**ROCKFORD BOARD OF EDUCATION  
INVITATION FOR BID ON SUPPLIES, MATERIALS, EQUIPMENT OR SERVICES  
FOR SCHOOL DISTRICT NO. 205  
ROCKFORD, ILLINOIS**

IFB No.        **17-40 Rockford Public School District 205 School B, Zone 1**

RE:        **ADDENDUM NO. 7**

Rockford Public School District 205  
School B, Zone 1  
Rockford, IL  
Cannon Project No. 005005.00

DOOR SCHEDULE

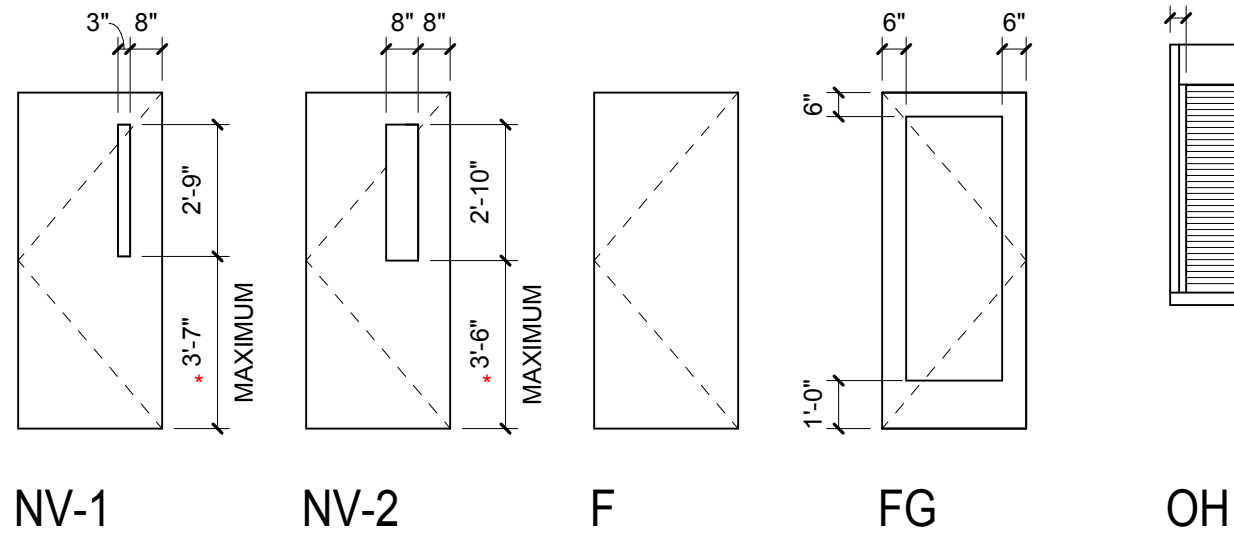
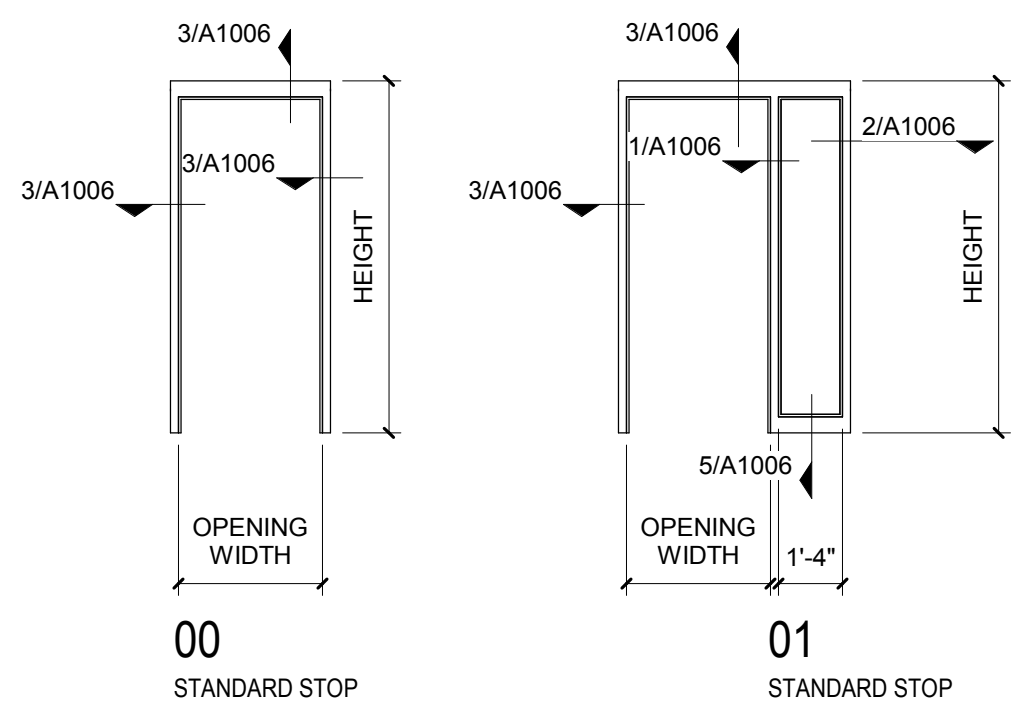
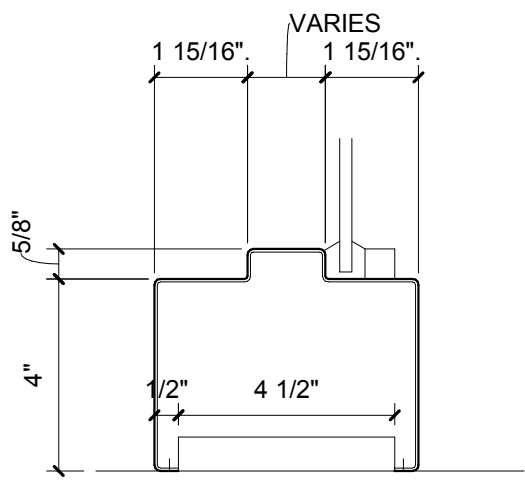
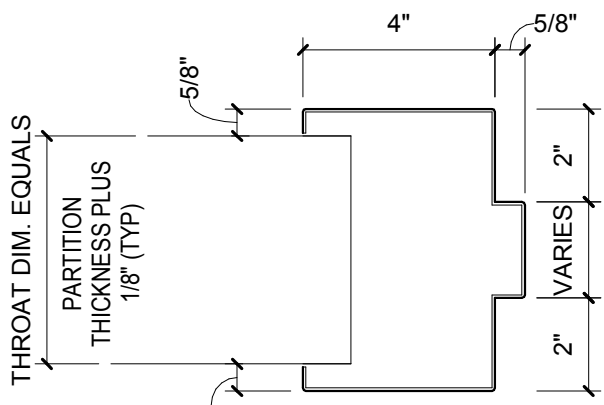
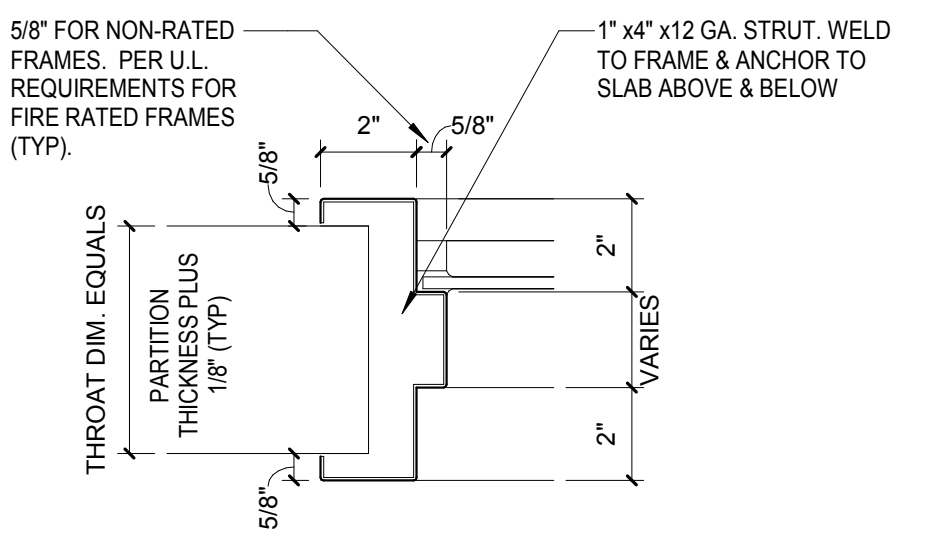
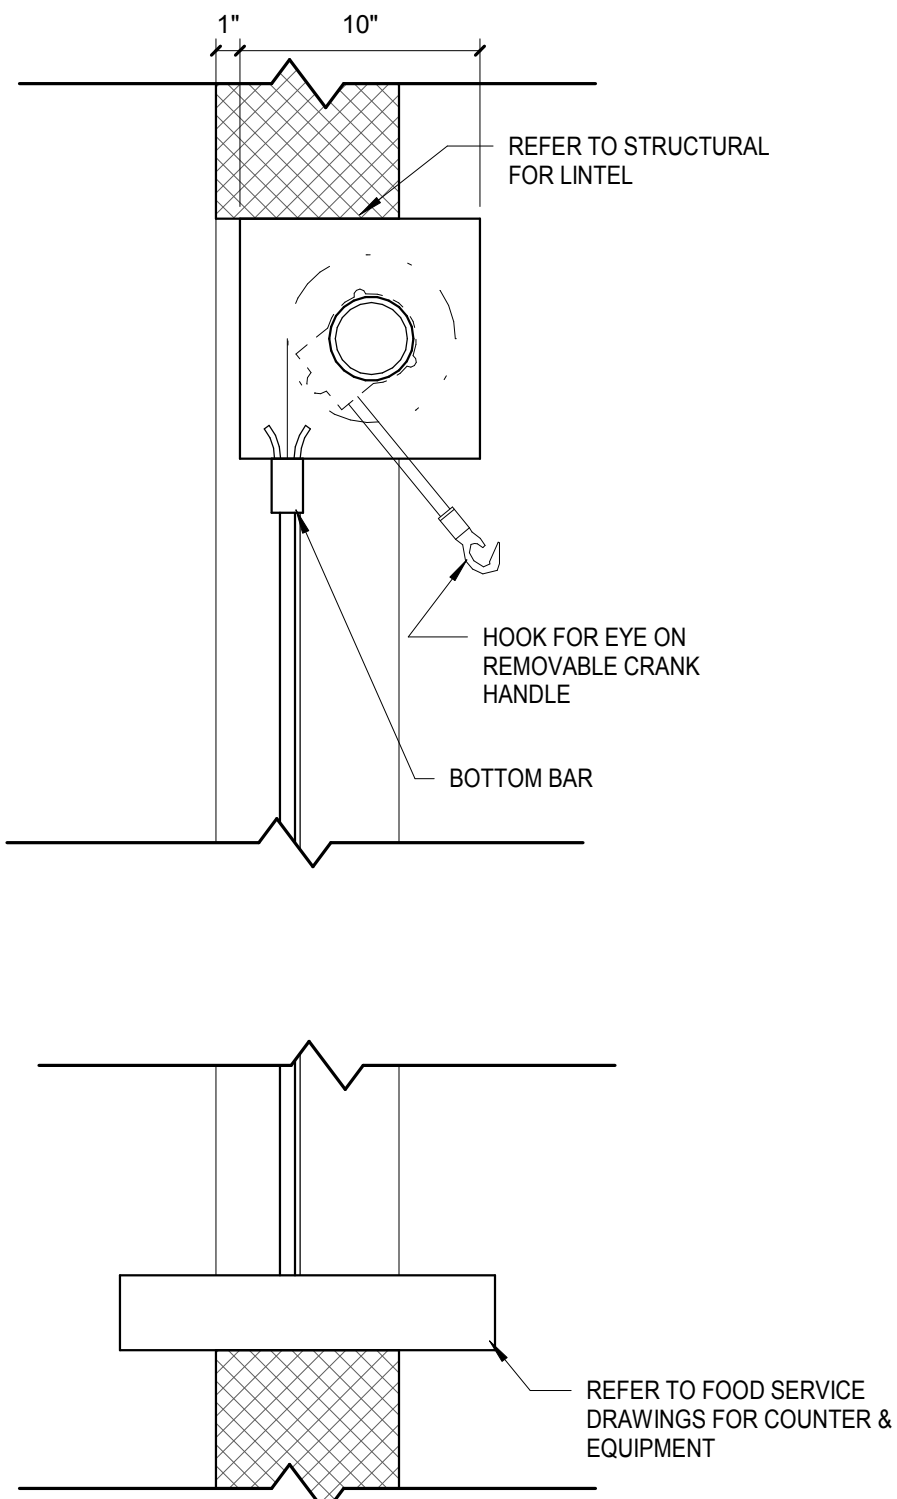
1. A1006 – DOORS & BORROWED LIGHTS SCHEDULE
  - B. Drawing A1006 is being issued as an attachment to this Addendum.

26	Greg Olson Section 8 Doors & Hardware, LLC. 815-385-5977 gregsection8@aol.com	6/1/2017	6/6/2017	On Addendum #5 the Architect changed 15 hardware sets with a note that said not used, they were used and were not replaced with new ones, this effects 44 openings.	Refer to Addendum 7.
27	Scott Beaver sbeavers.sbs@gmail.com Security Builders Supply Co. 5077 American Rd. Rockford, IL 61109 Phone (815) 873-1040 Fax (815) 873-1042	6/1/2017	6/6/2017	Per addenda No. 5 there are 17 Hardware sets that are not to be used. This effects 49 different openings. What hardware sets do we assign to these 49 openings?	Refer to Addendum 7.
28	Joe Madonia Estimator IHC Construction Companies, LLC (847) 742-1516 jmadonia@ihcconstruction.com	6/2/2017	6/6/2017	Is a new Sheet A1006 Door Schedule being issued? Addendum # 5 Specification hardware schedule has eliminated hardware sets that are still on the Plan Sheet A1006 door schedule.	Refer to Addendum 7.
